62 Southern Cross Way, Allambie Heights

New DA.

PRELIMINARY GEOTECHNICAL ASSESSMENT:

Photo 1

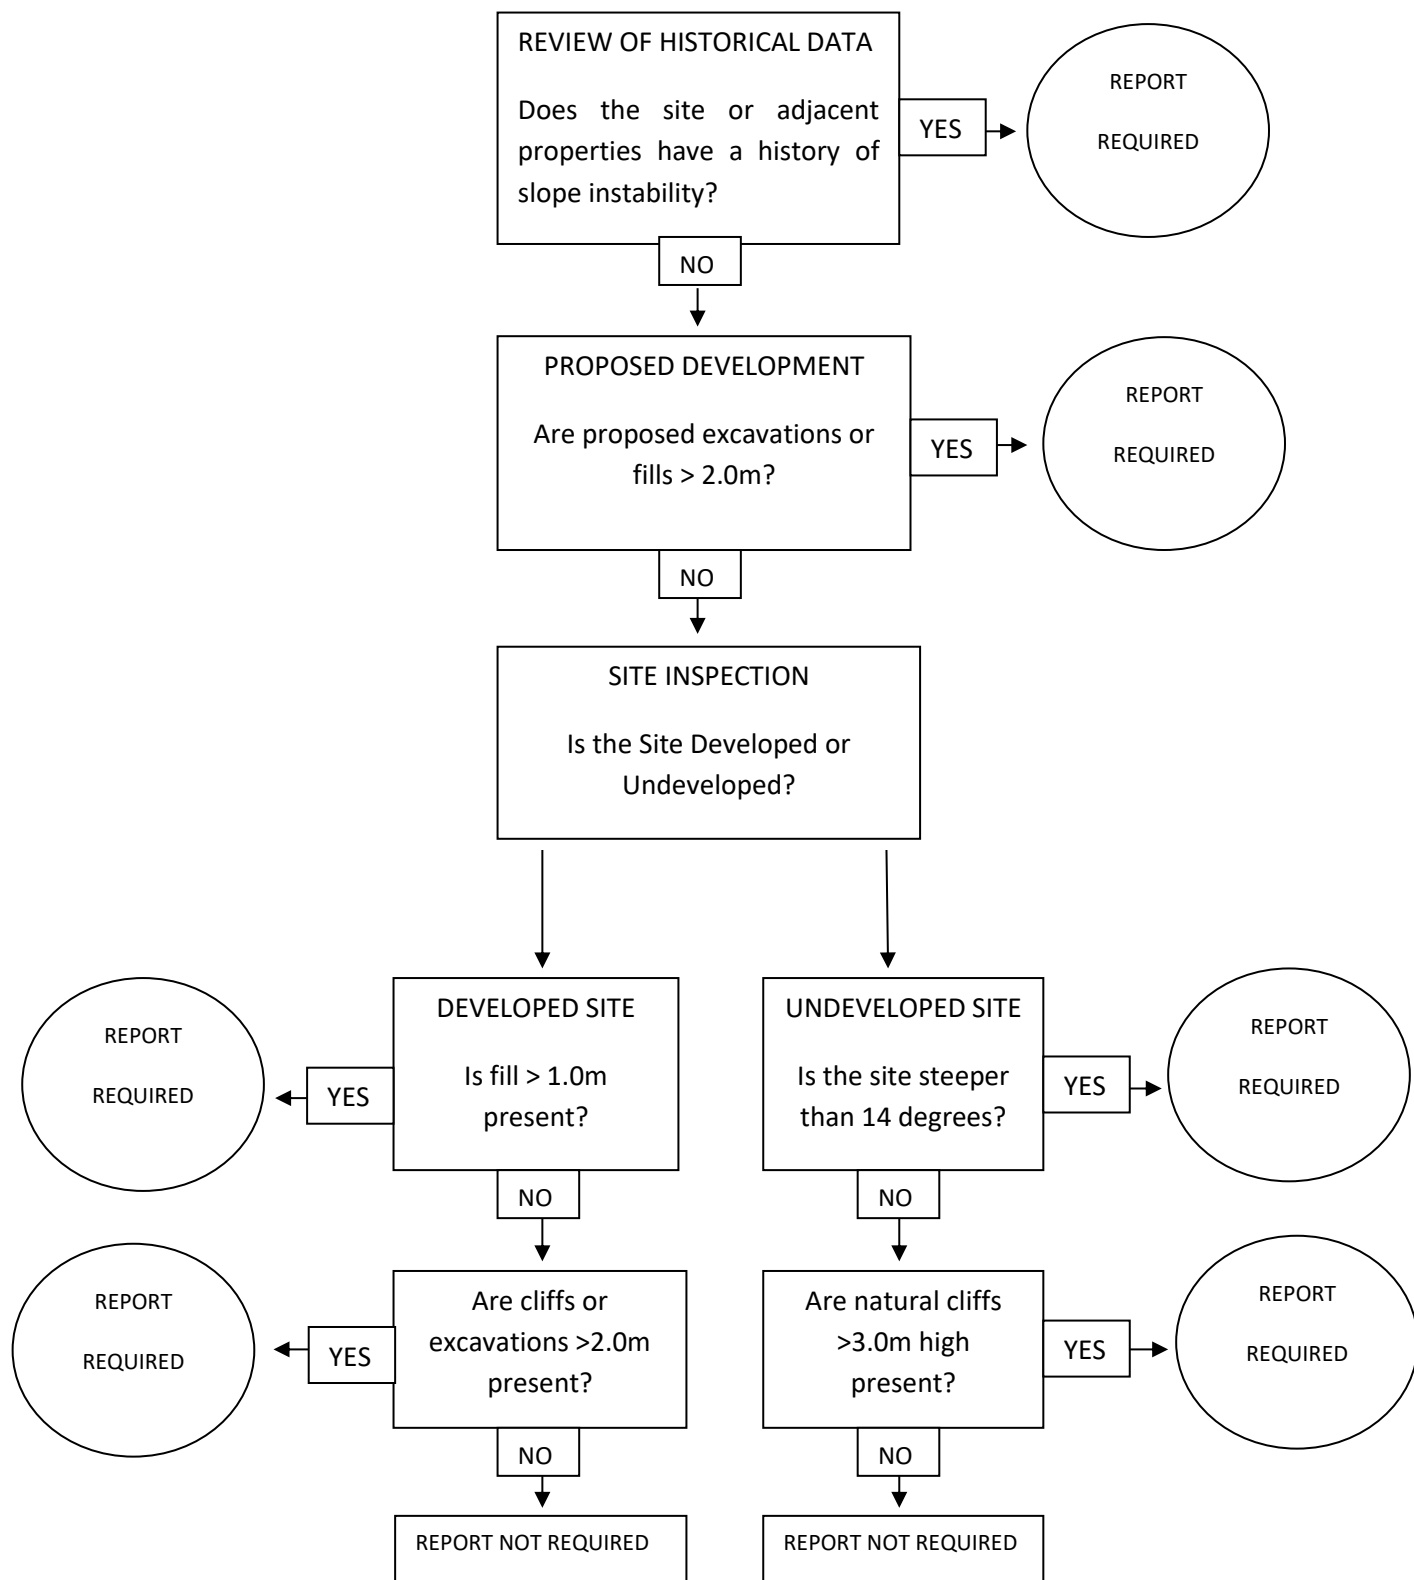
The concrete block retaining wall on the uphill side of the property is tilting downslope to ~4° (Photo 1). We recommend consideration be made to repairing/replacing the retaining wall during the proposed works to the carport. Alternatively, the retaining wall can be inspected by the owners on an annual basis or after heavy prolonged rainfall, whichever occurs first, keeping a photographic record of the inspections. We can carry out these inspections upon request. Should any new movement be observed, the retaining walls are to be remediated or rebuilt to current engineering standards.
